# CITY OF SANTA BARBARA

## COUNCIL AGENDA REPORT

**SUBJECT:** Appeal Of Architectural Board Of Review Approval Of 1911 Chino Street

DESCRIPTION: EXTERIOR ELEVATIONS  
 PROJECT: ADD 1 SINGLE FAMILY RESIDENTIAL UNIT  
 1811 CHINA ST  
 SANTA BARBARA, CA

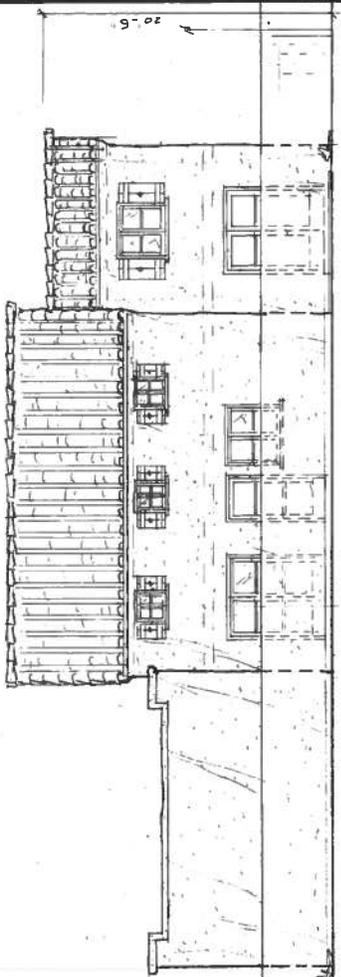
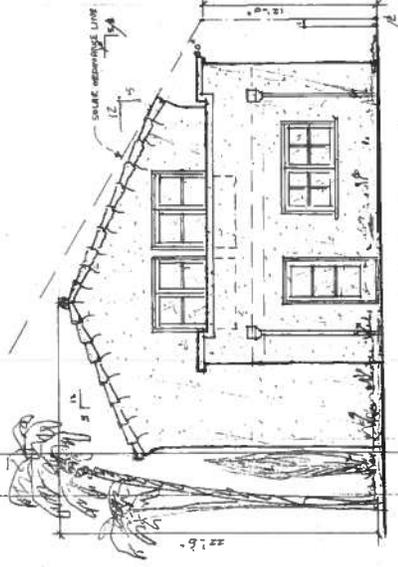
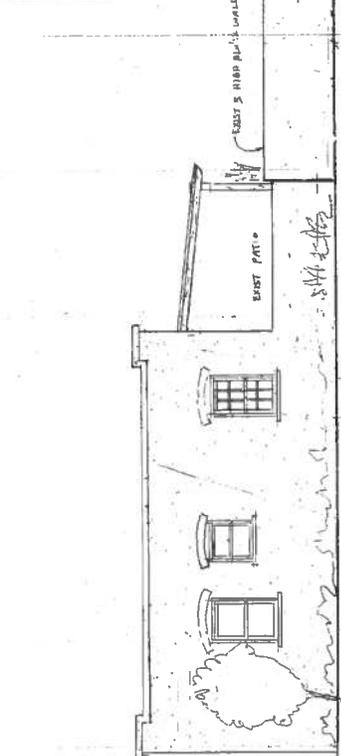
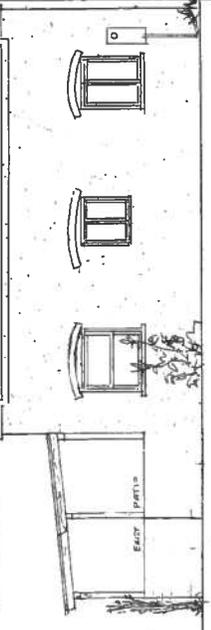
1. It seems the drainage as drawn will run off into the neighbor's property. A drainage plan for the whole length of the property is in order. It only shows a 1% slope.

2. The sloped roof line does not match the front house, which has a flat roof. A flat roof seems a more consistent design.
3. Regarding the balconies, the design shows access from sliding doors. It was suggested at the previous hearing that the balconies be faux and there be windows, not doors.

6. There is no outdoor lights shown on the plans. Will they be on all night? Will they shine into our windows? Where will the lights be placed?
7. There is a sliding glass door onto the garage roof. What is the height of the garage walls? Will there be a railing surrounding this outdoor space? How high? Again, how will this barrier block our mountain views?

8. Regarding the garbage enclosure by the front house, what will it be made of? How high?
9. There are windows in the closets of the bedrooms. Why?
10. We suggest a short wall at the turn of the walkway be built to protect the yard in front of the entrance and to mark the end of the long driveway.

3. There are no water heaters shown. Where and what type. Instantaneous on the exterior? The heating system is not shown.
4. The upstairs bedroom windows have been relocated to the north side in the closets.?
